**STAFF REPORT**  
(Preliminary Plat)

**CASE NUMBER:** SUB 2003-88 -- WICHITA CLINIC ADDITION

**STAFF REPORT**  
(Final Plat, Preliminary Plat Approved 8/14/03)

**CASE NUMBER:** SUB 2003-88 -- WICHITA CLINIC ADDITION

PAVING CONCEPT  
OPTION 1 8-13-03

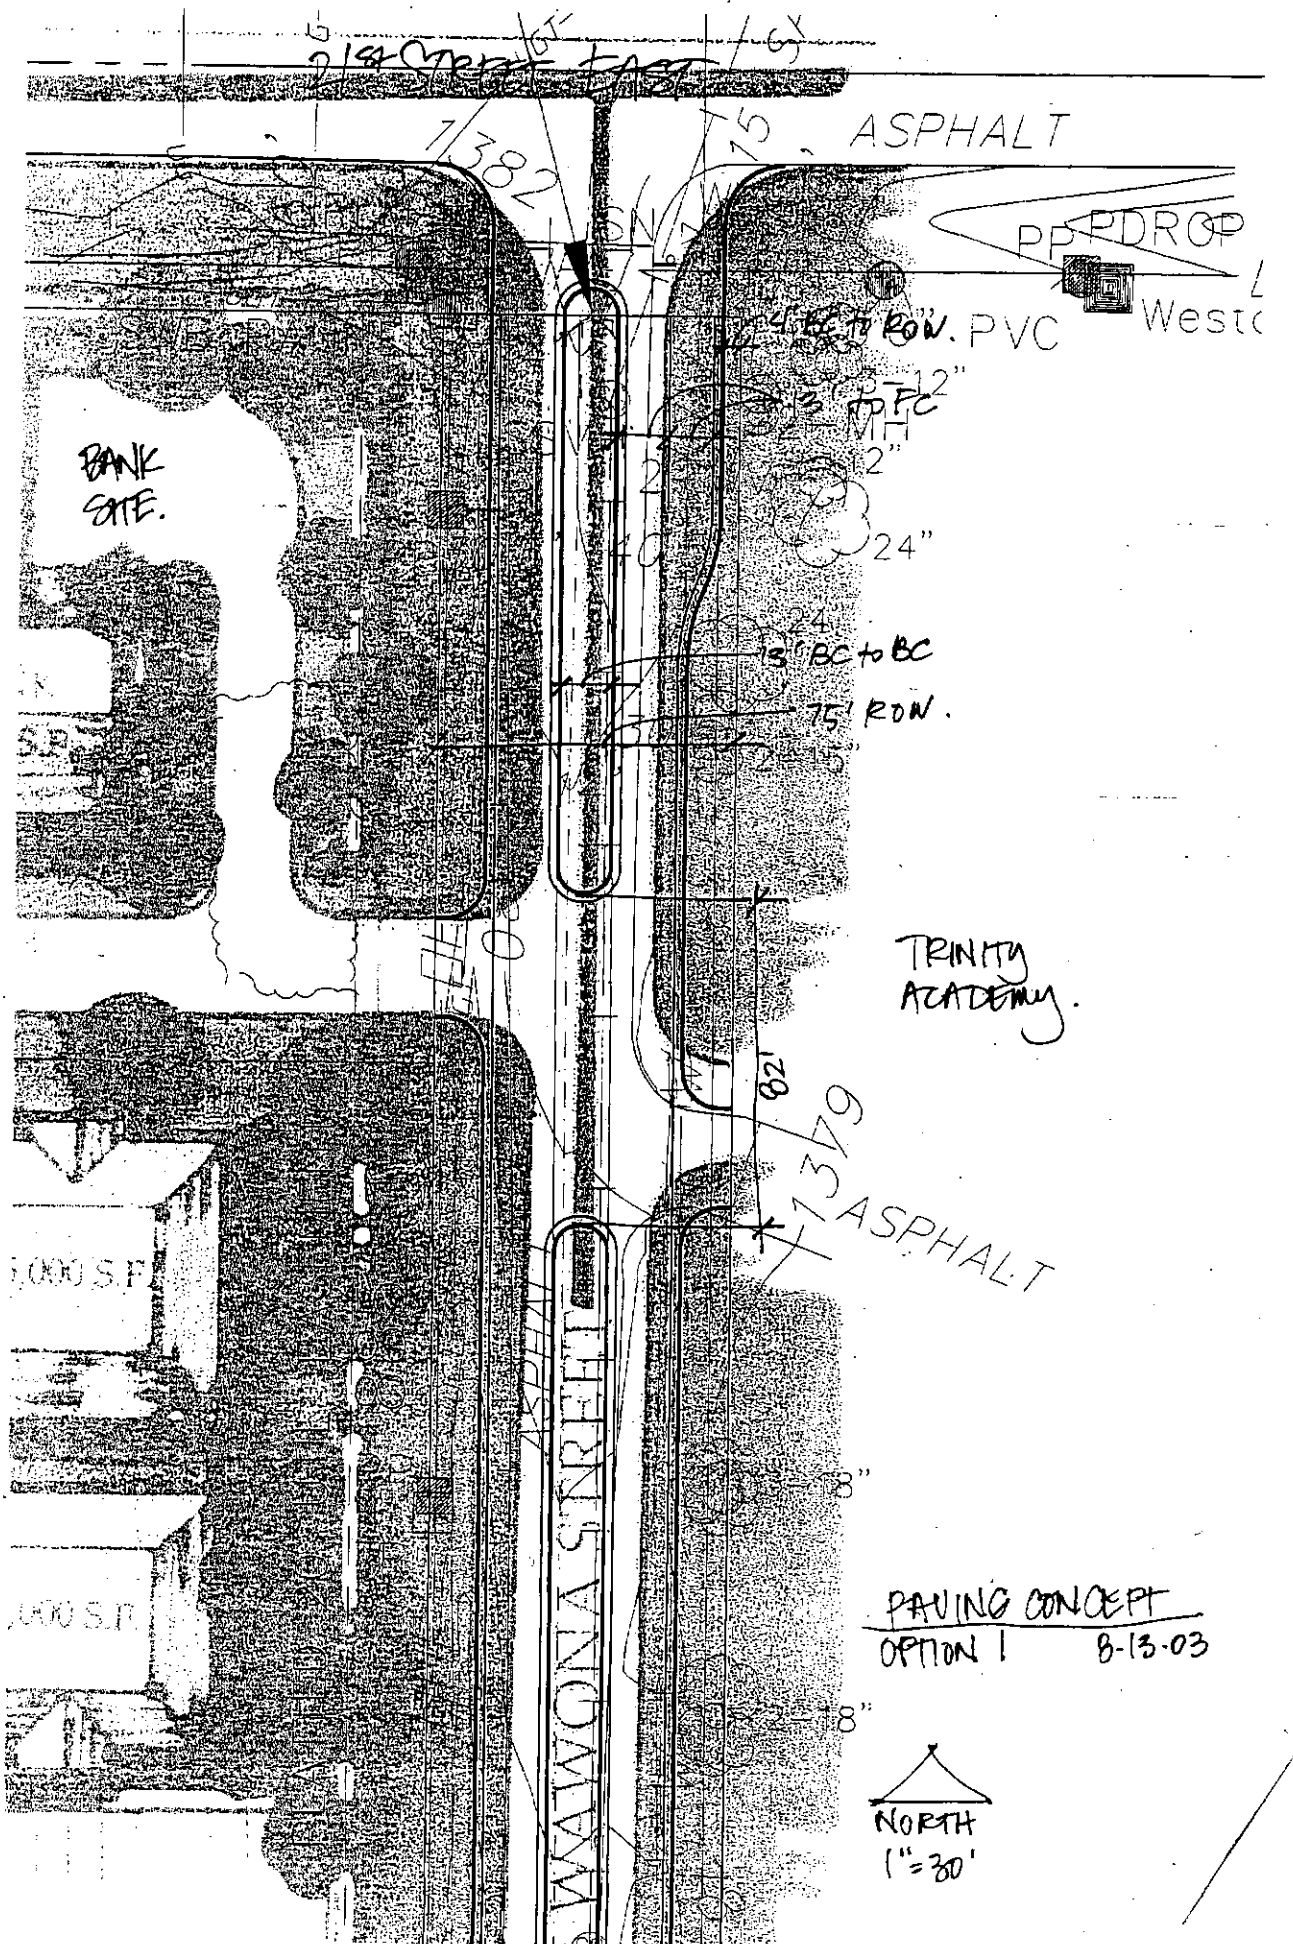
- D. Traffic Engineering and City Fire Department need to comment on the need for additional street right-of-way along Founders Cir. A 70-ft street right-of-way width (41-ft roadway width) is needed to conform with commercial street standards. The right-of-way width has been approved by Traffic Engineering and City Fire Department. A restrictive covenant is needed to restrict Founders Cir to No Parking. City Fire Department requests 20-ft roadway for ingress and 29-ft roadway for egress at the Founders Cir entrance.

- E. The Applicant shall guarantee the paving of the proposed street to the business/industrial street standard. City Engineering has requested a cross-section of the proposed street to determine paving requirements.
